ISSUE: Permit to Demolish/Capsulate (partial) and Certificate of Appropriateness

APPLICANT: Robert B. & Jane J. Wallace

1113 Prince Street

Docket #8 & 9 BAR #2022-00251 & BAR #2022-00264 Old and Historic Alexandria District June 15, 2022

PROPOSED WEST ELEVATION SHEET TITLE

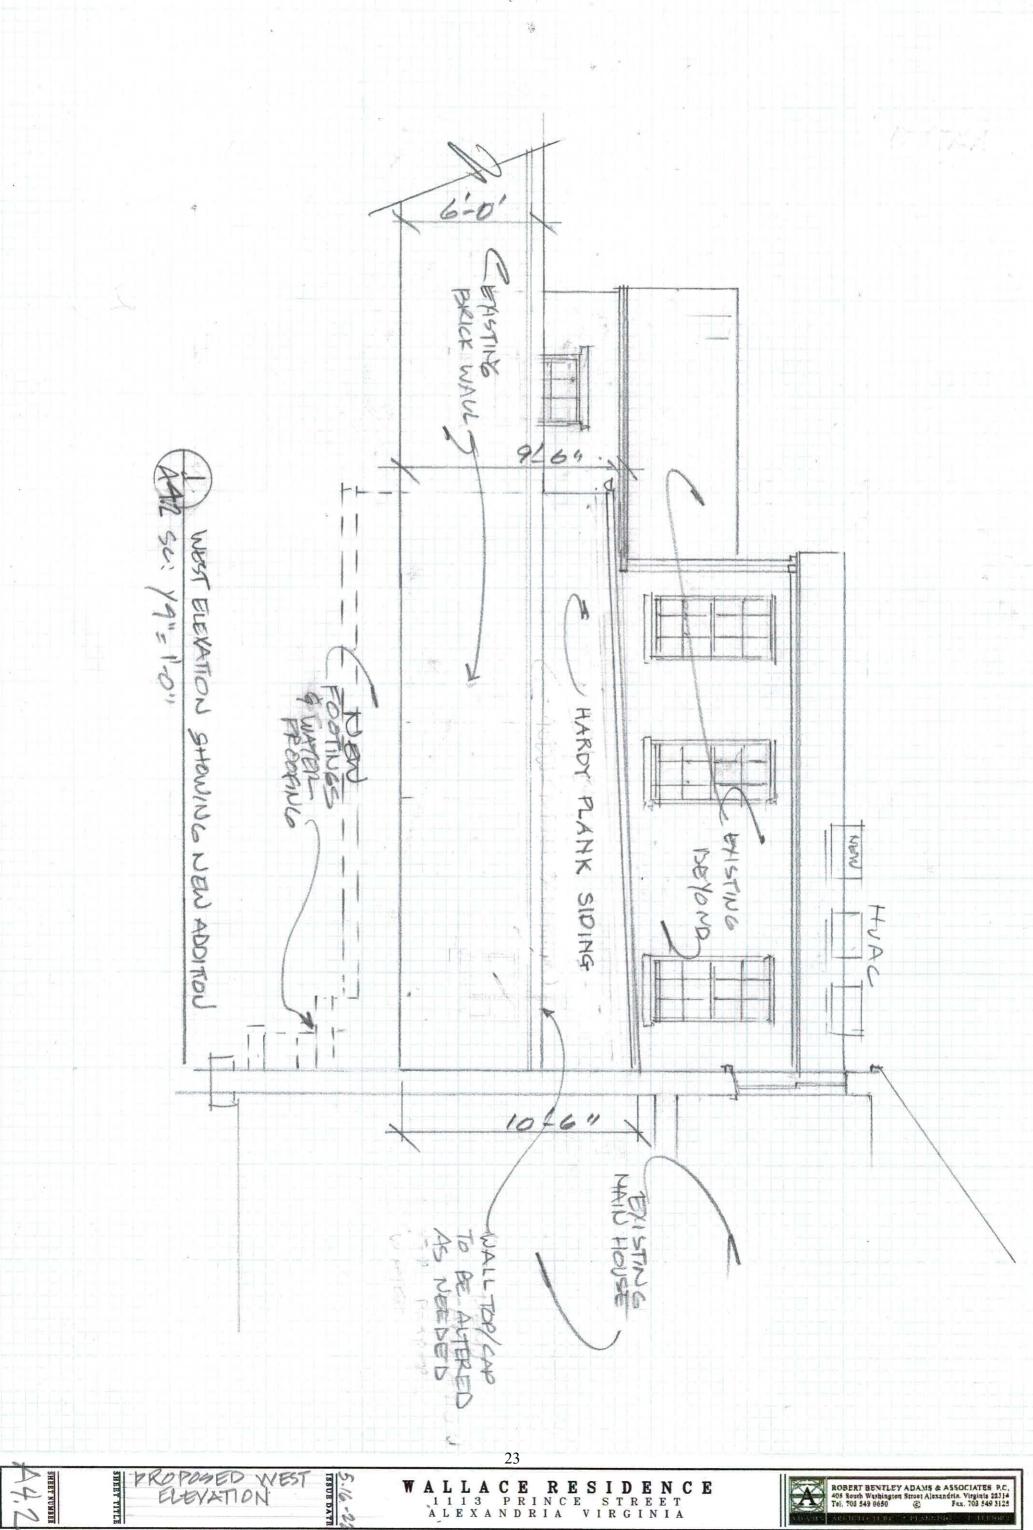
Staff has no objection to the construction of a one-story addition on the side of the existing rear ell. The addition will be functionally not visible from the public way and will not detract from the historic character of the main historic building or the historic district. Furthermore, the Board routinely approves changes on the rear elevations of historic buildings to accommodate a more modern and functional interior layout as tastes and technology evolve. The existing rear elevations do not exhibit a high level of design or architectural detail as well.
